ADDENDUM NO. 5
NEW SOFTBALL COMPLEX FOR TRUSSVILLE CITY SCHOOLS
Architect Job No. 23-72
April 17, 2024
DCM # 20240224

The Plans and Specifications are here by amended. The following supersedes all contrary and/or conflicting information and is made part of the contract documents.

A3.2

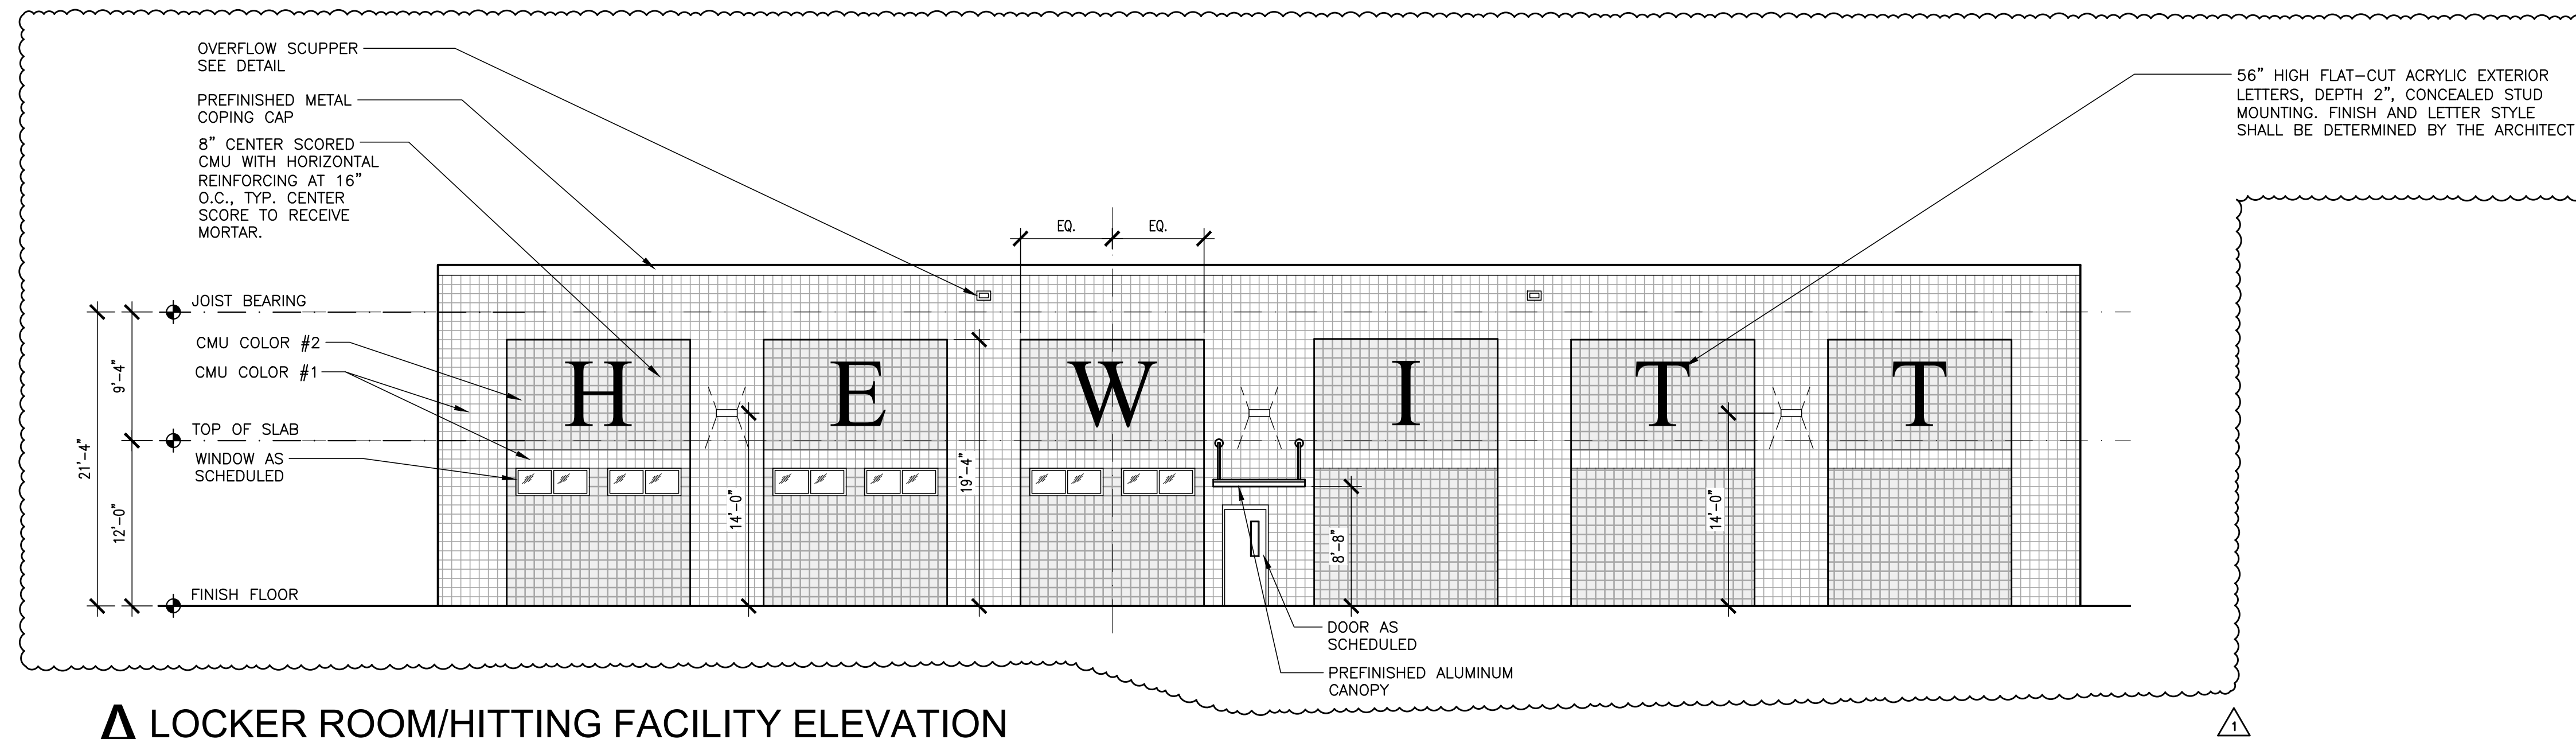
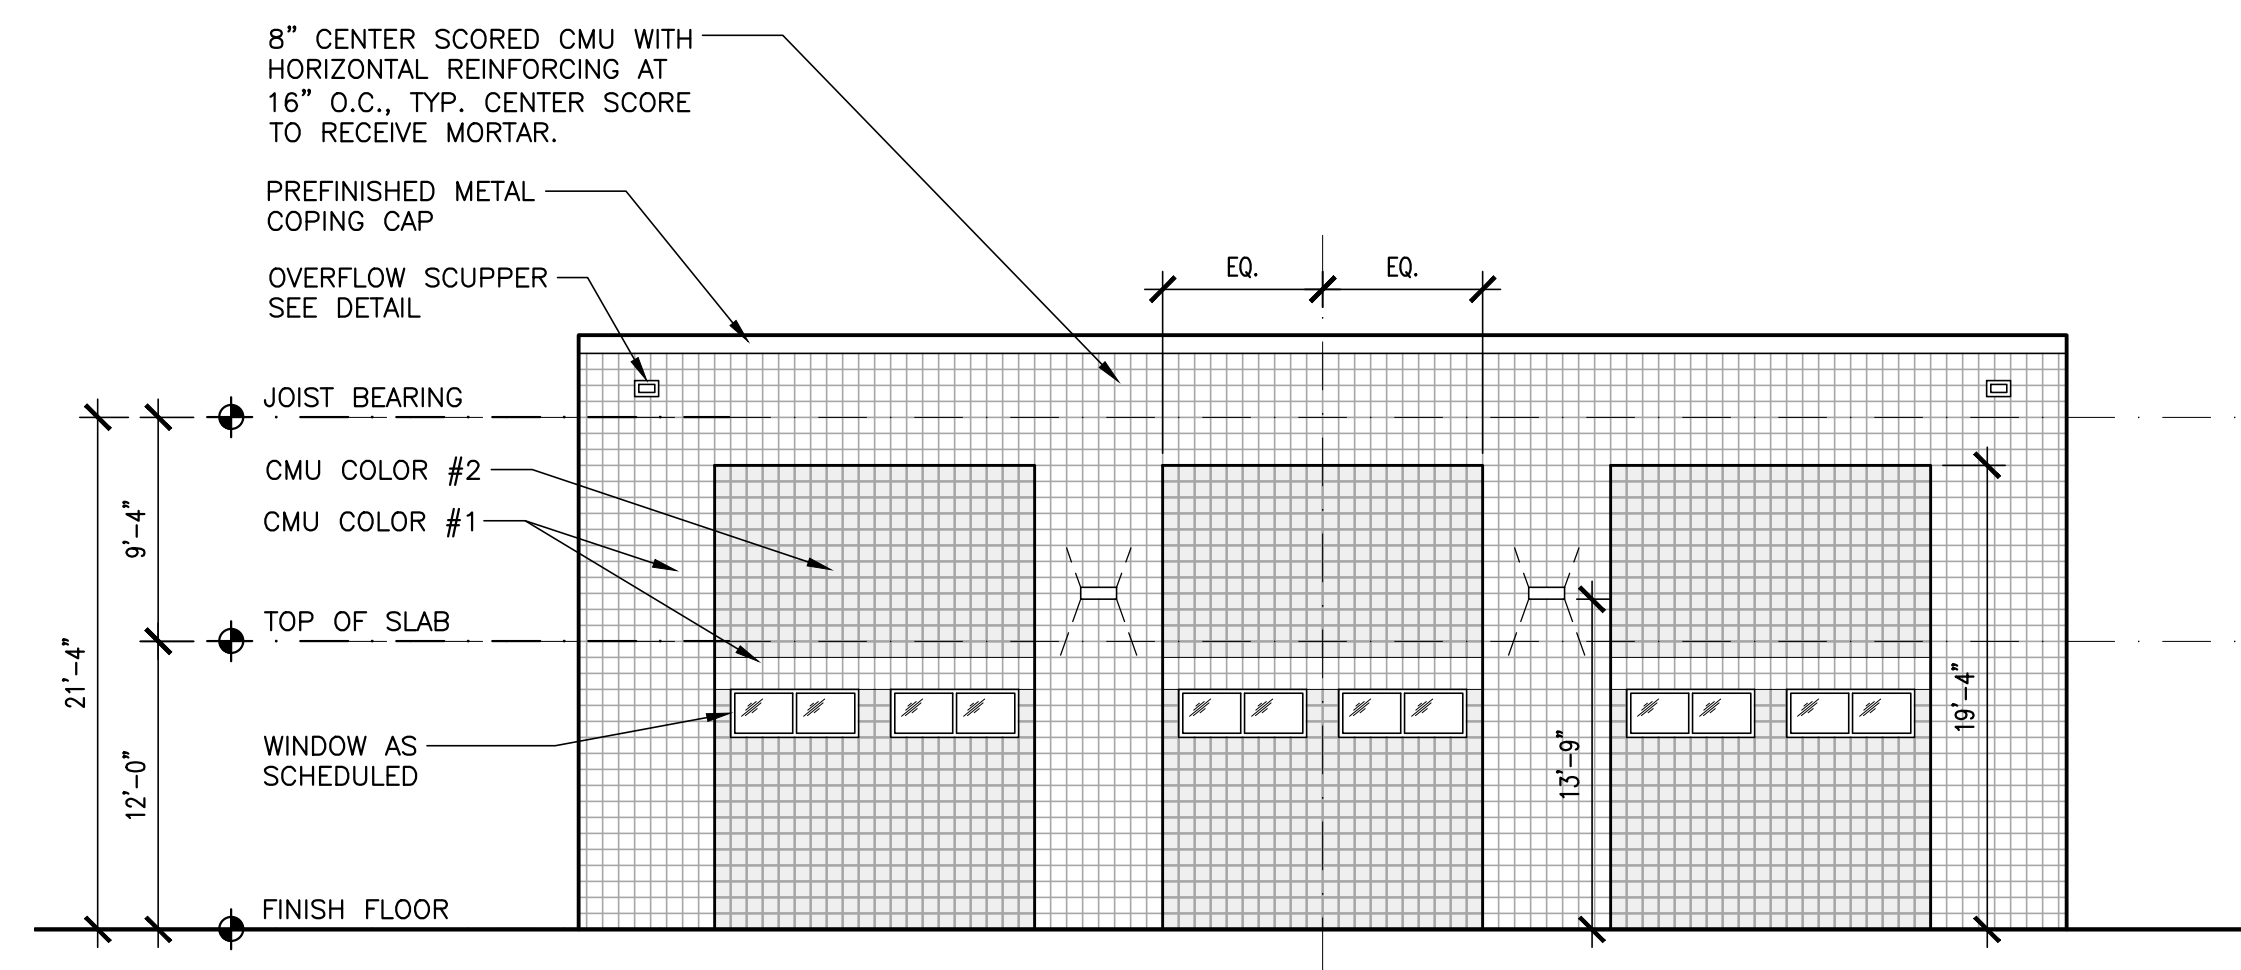
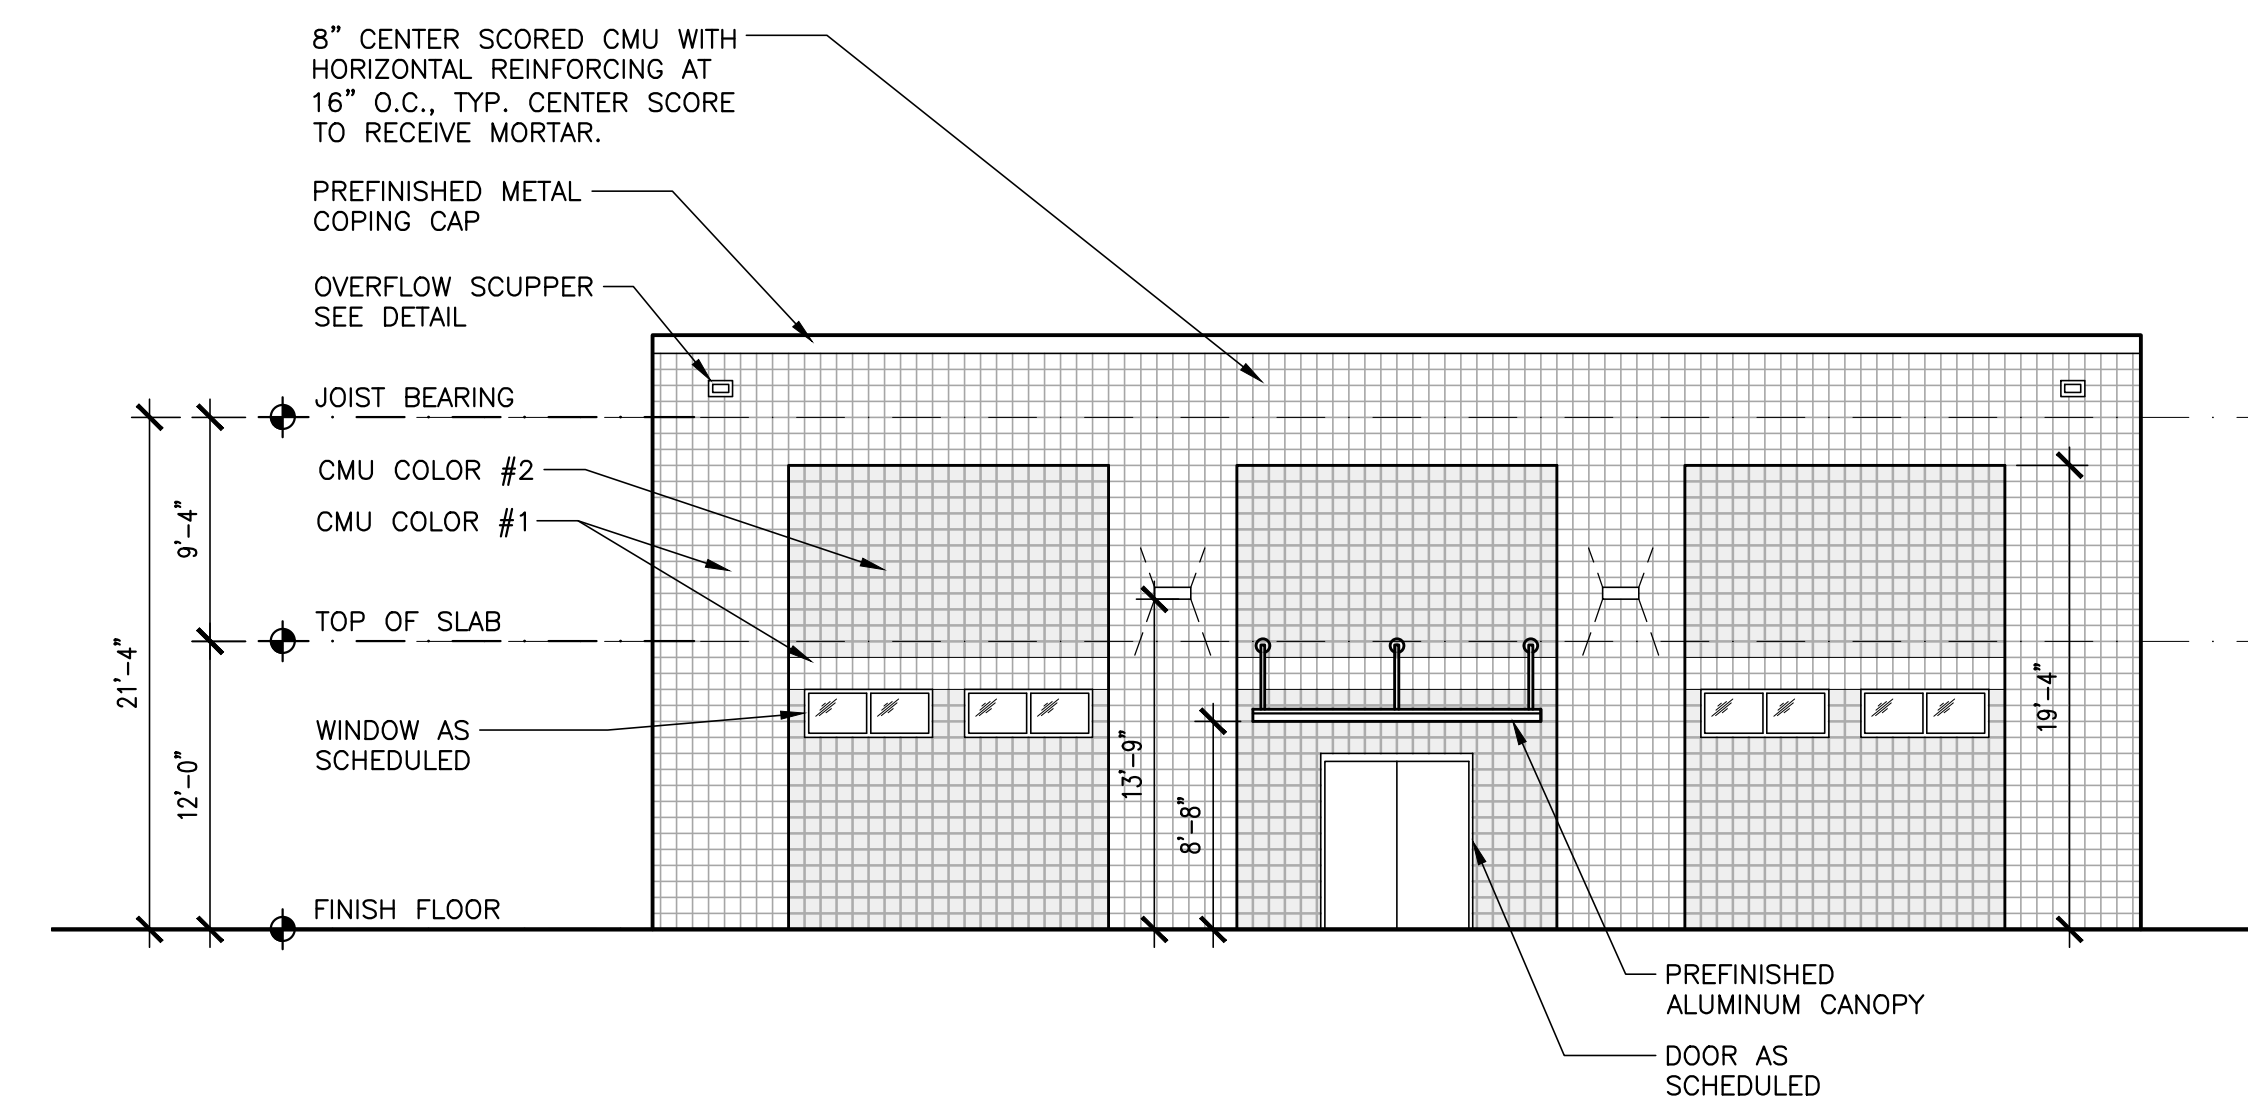
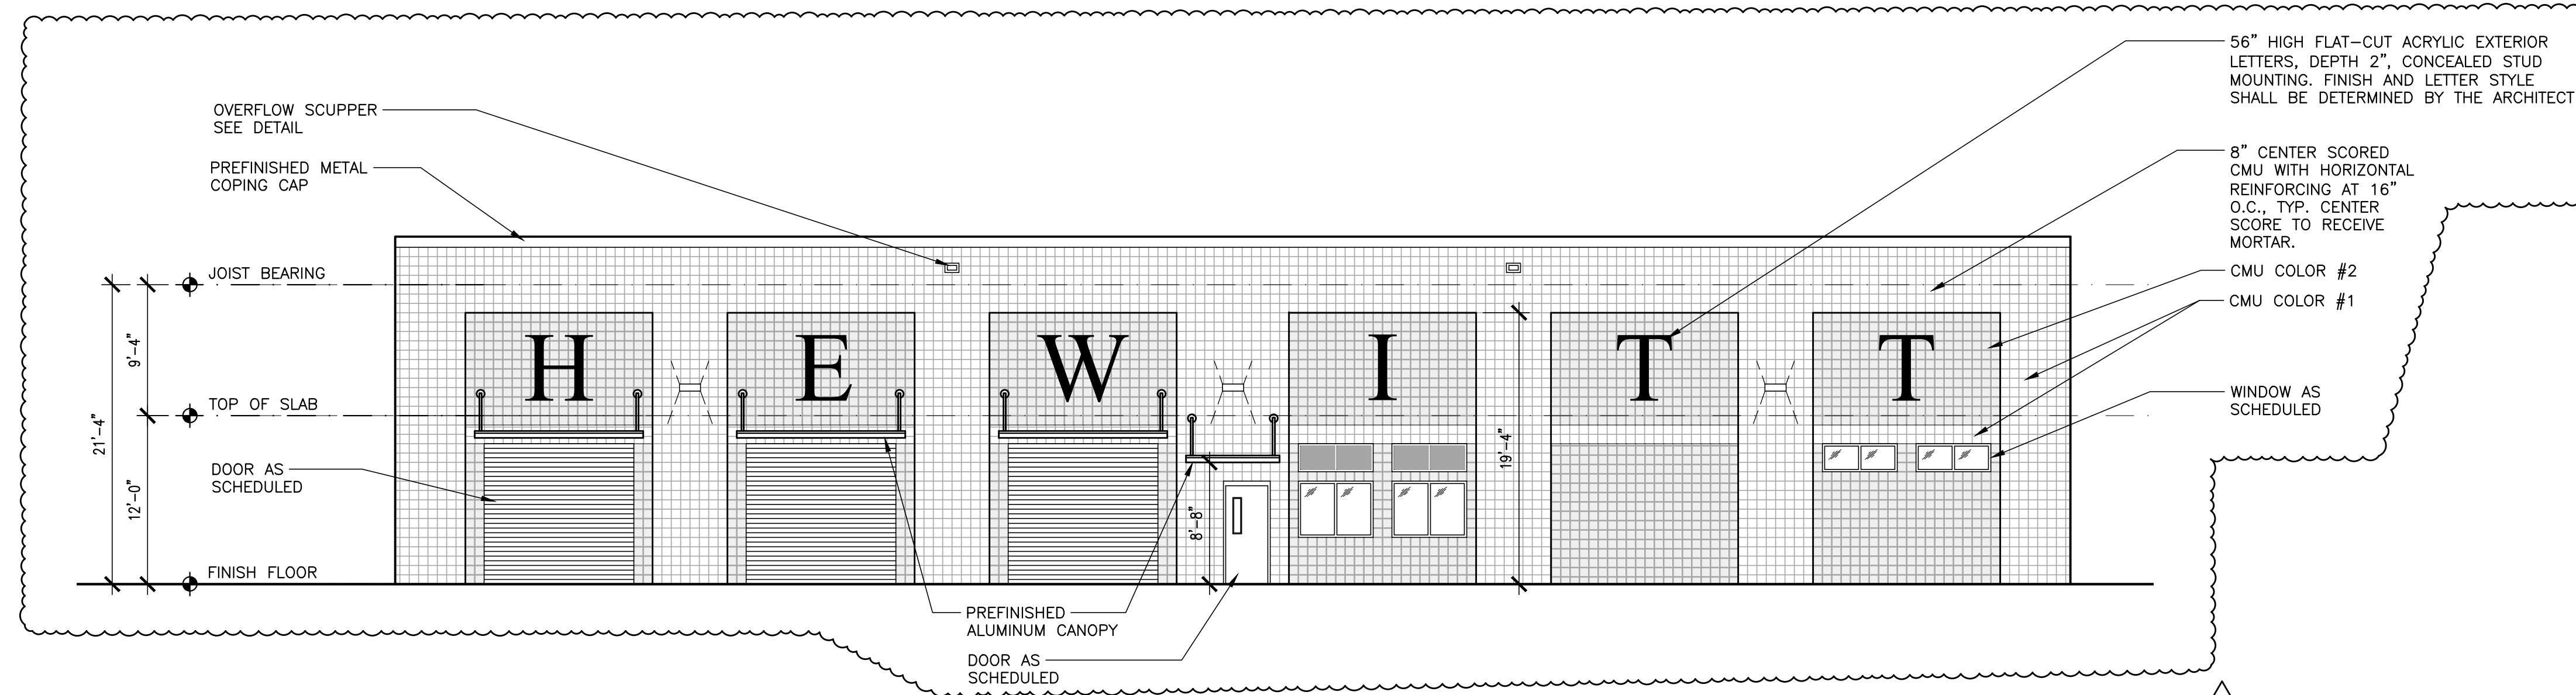
5. See the attached REVISED Sheet **A3.1** for revisions to Concessions / Bleacher Elevations adding building signage.
6. See the attached REVISED Sheet **A3.2** for revisions to Locker Room / Hitting Facility Elevations adding building signage.
7. See the attached REVISED Sheet **S2.2** for revisions to Press Box Foundation and Upper Framing Plan.
8. See the attached REVISED Sheet **S2.3** for Press Box Roof Framing Plan.
9. See the attached REVISED Sheet **E1.1** for revisions to Schedules, Symbols, and Notes.
10. See the attached REVISED Sheet **E2.1** for revisions to Site Plan and Single Line Diagram.
11. See the attached REVISED Sheet **E3.1** for revisions to Floor Plans – Lighting.
12. See the attached REVISED Sheet **E4.2** for revisions to Floor Plans – Power.
13. See the attached REVISED Sheet **E6.1** for revisions to Softball Field Lighting Plan.
